NUREG/CR-1512
ATR-80(7814)-1

Evaluation of Materials Interactions for Advanced Reactor Systems

Annual Progress Report

The Aerospace Corporation

Figure 1. Compressive Strength of Concrete After Heating to High Temperatures (A. M. Neville, "Properties of Concrete," John Wiley and Sons, Inc., New York, 1963)

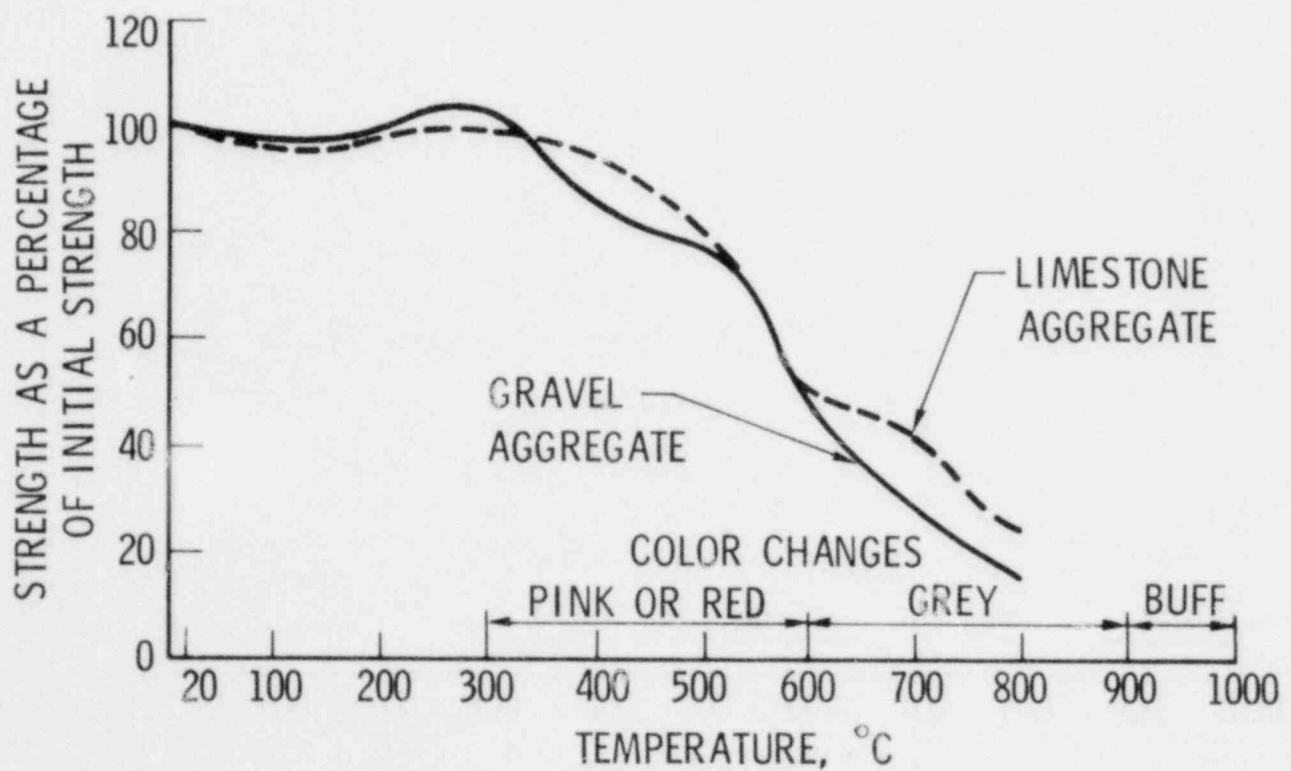
In the range between room temperature and 300°C, both limestone aggregate and basalt aggregate concretes retain their initial compressive strengths,⁸ to within ±5 percent (see Figure 1). At 550°C, both types of concrete retain approximately 70 percent of their initial compressive strengths. Limestone retains approximately 40 percent of its compressive strength while basalt retains only 30 percent of its initial strength at a temperature of 700°C. At 800°C, limestone aggregate concrete is down to 25 percent and basalt aggregate is down to 15 percent of its initial strength.⁸

In conclusion, a vertical, nonstructural wall of concrete should hold together without difficulty at temperatures of about 900°C. As long as the concrete retains a significant percentage of its original strength, it will not disintegrate.
